ANNOTATED SHEET SHOWING CHANGES

FIG. 3

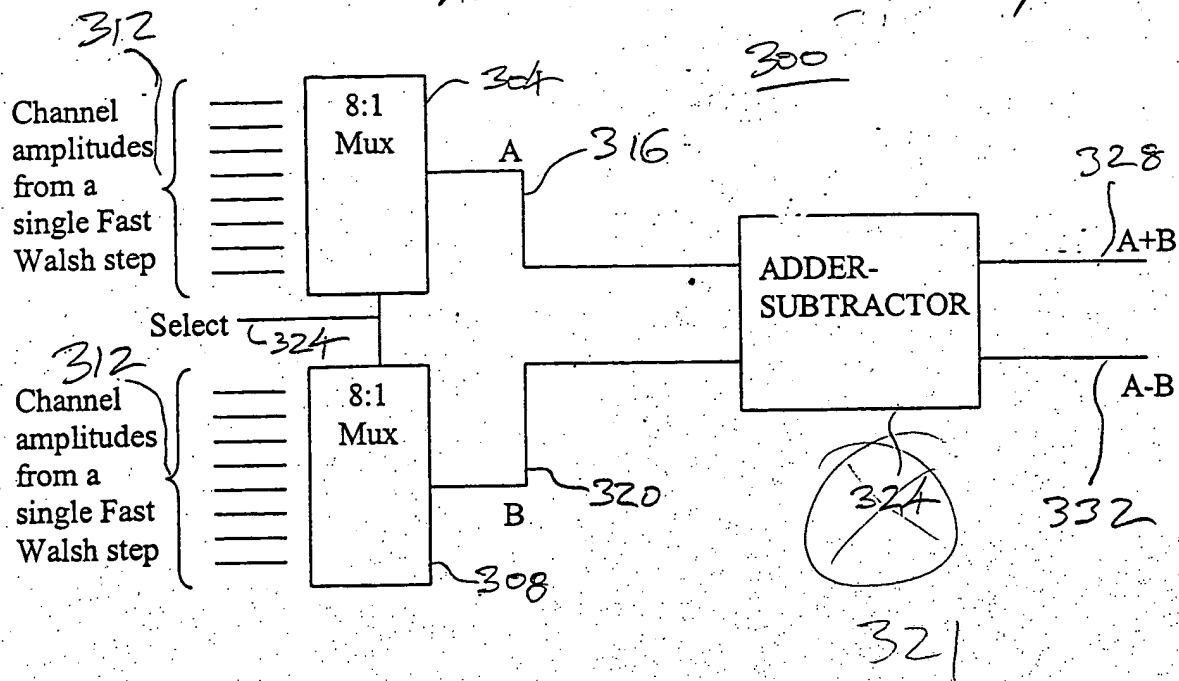
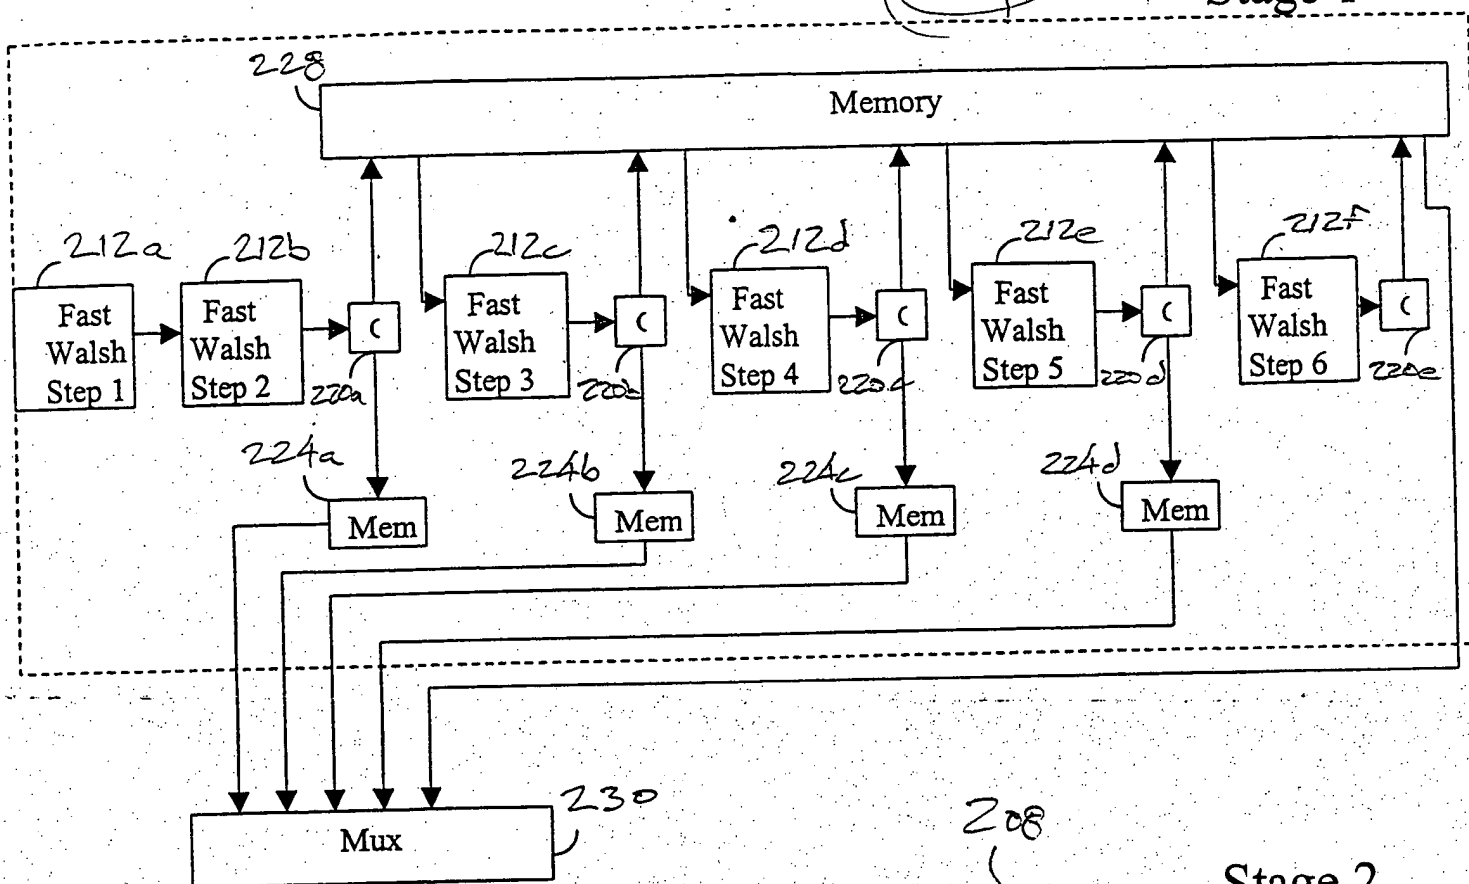
outputs 316, 320. The outputs 316, 320 of the multiplexers 304, 308 are provided to an adder or subtractor ~~324~~ 321. The adder – subtractor comprises an adder that provides a first output 328 comprising a value resulting from the addition of the value output by the first multiplexer 304 on output line 316, and the value output by the second multiplexer 308 on input line 320. The adder – subtractor ~~324~~ 321 additionally includes a subtractor that provides as an output the subtraction of the value provided by the second multiplexer 308 from the value provided by the first multiplexer 316 on second output line 332. --
